ELECTRICAL AND MECHANICAL
ENGINEERING INSTRUCTIONS

TRUCK, LIGHTWEIGHT, MC2, LAND ROVER 110 4X4 - ALL TYPES NOT FITTED
WITH SNORKEL

REPOSITIONING OF THE AIR INLET HOSE AND REAR AXLE BREATHER

MODIFICATION INSTRUCTION

Figure 1 - Relocation of Air Inlet Hose

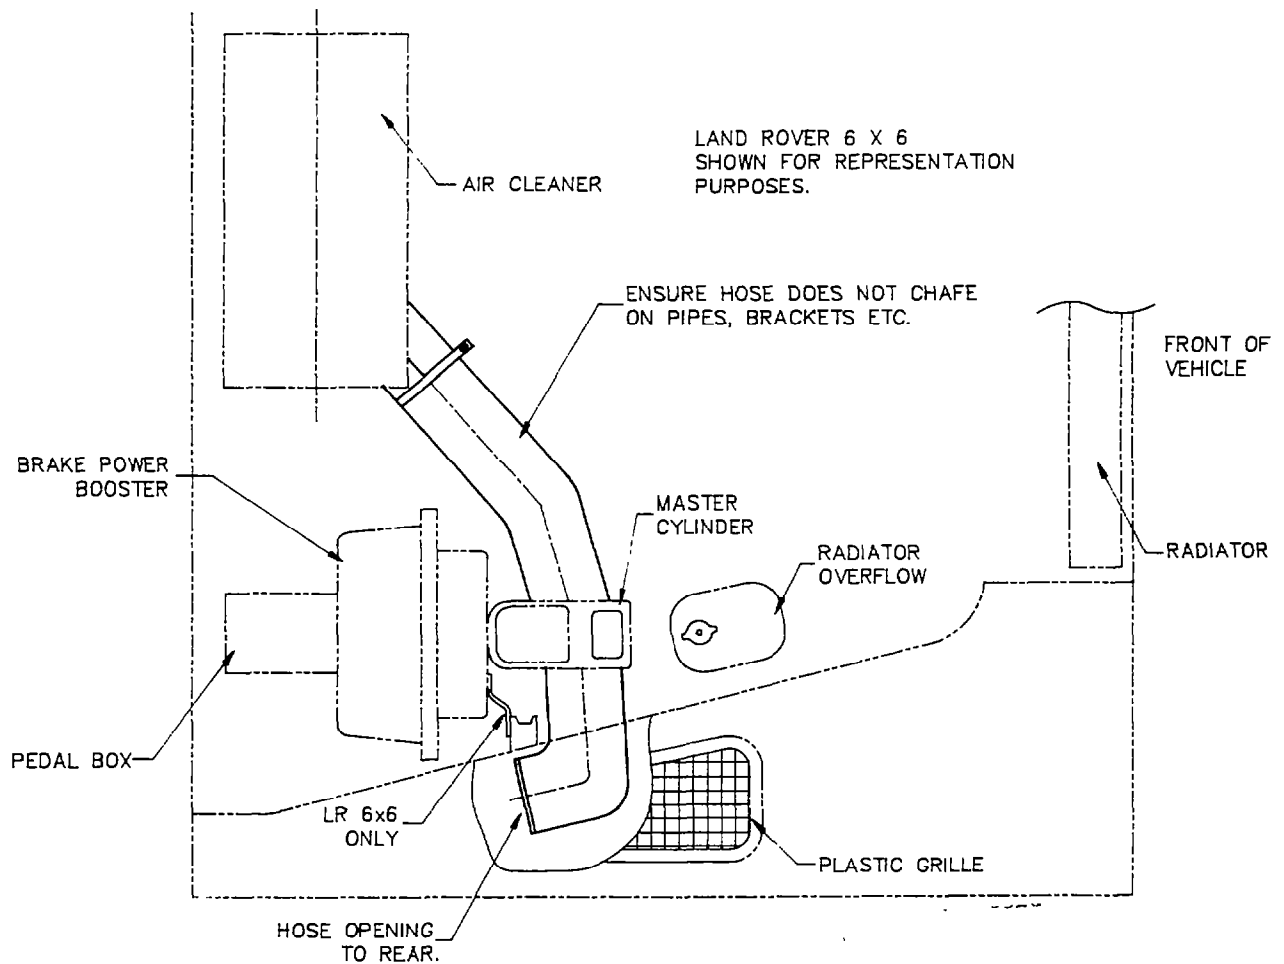
- a. Remove the air inlet hose from the vehicle, check the hose for damage and if necessary order a new hose (Item 1, Table 1).
- b. Refit the hose, as shown in Figure 1, so that the hose opening points to the rear of the vehicle and the hose does not chafe on other pipes, cables, hoses or objects able to damage the inlet hose.

Figure 2 - Fitting of Rear Axle Breather Section

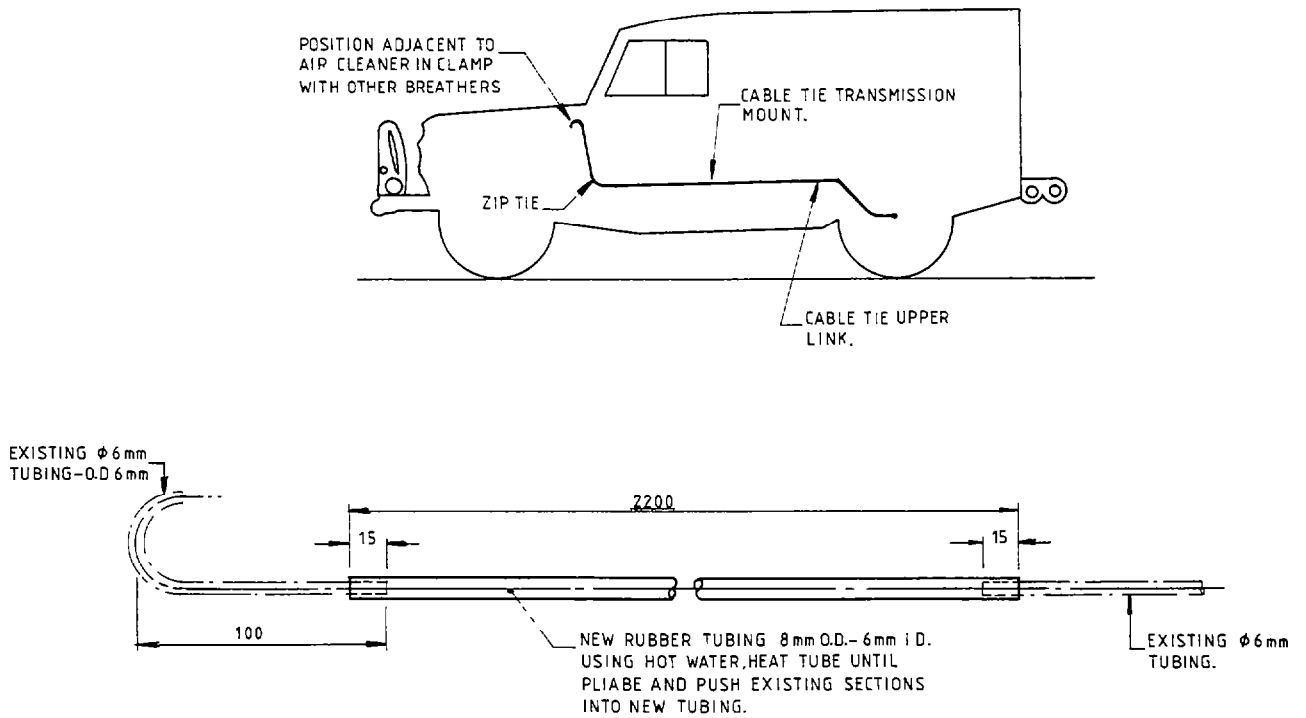
13. Rework the Land Rover 4x4 rear axle breather as follows, with reference to Figure 2:

- a. Remove the rear axle breather from the vehicle.
- b. Cut the hook end from the existing breather approximately 100 mm from the hook.
- c. Immerse one end of the breather section (Item 2, Table 1) in hot water to soften the section and force the hook end (previously cut off) approximately 1.5 cm into the breather section.
- d. Immerse the other end of the breather section in hot water and force the remaining breather hose section approximately 1.5 cm into the breather section.
- e. Route the breather along the left arm of the rear upper link, the chassis rail and body toe box. Position the hook end adjacent to the air cleaner and secure in the clamp holding the other breathers.
- f. Secure the breather in three places along the chassis utilising cable ties (Item 3, Table 1).

Figure 3 - Unprepared Fording Height and Depth Indicator Stencil Location

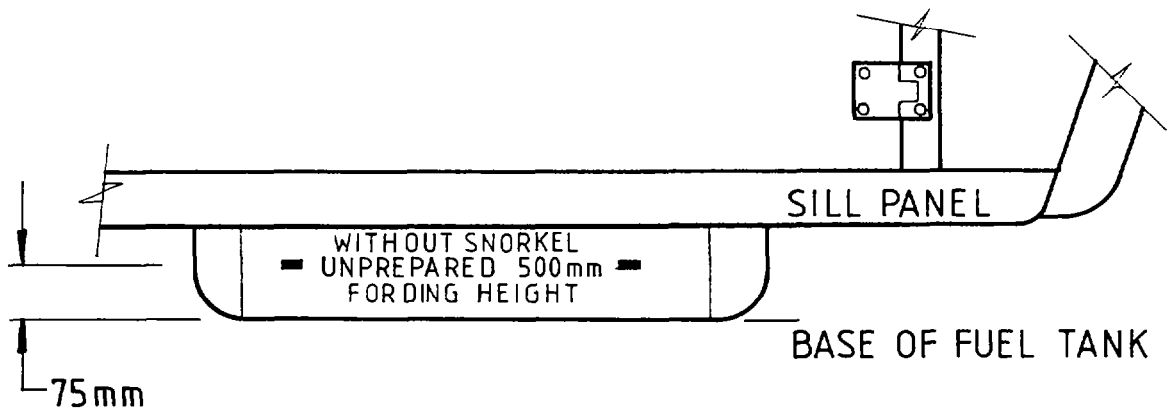
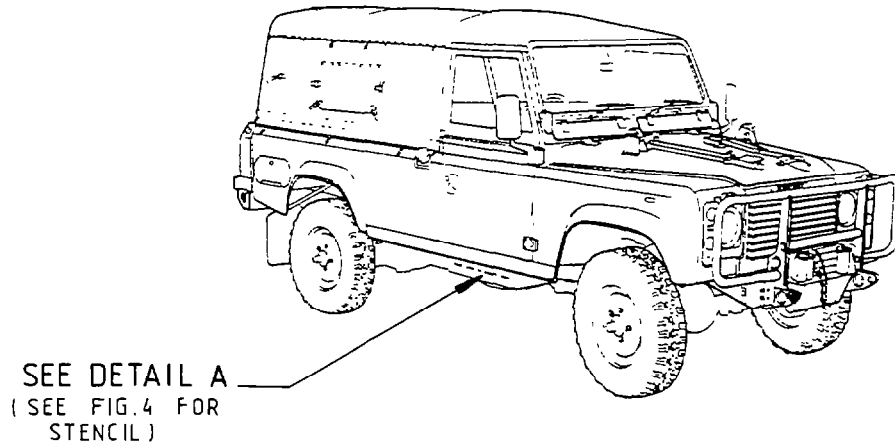
14. Figure 3 shows the location of the depth marker. Using the stencil shown in Figure 4, paint the message "WITHOUT SNORKEL UNPREPARED 500 MM FORDING HEIGHT" on the fuel tank in brown paint (Item 4, Table 1).
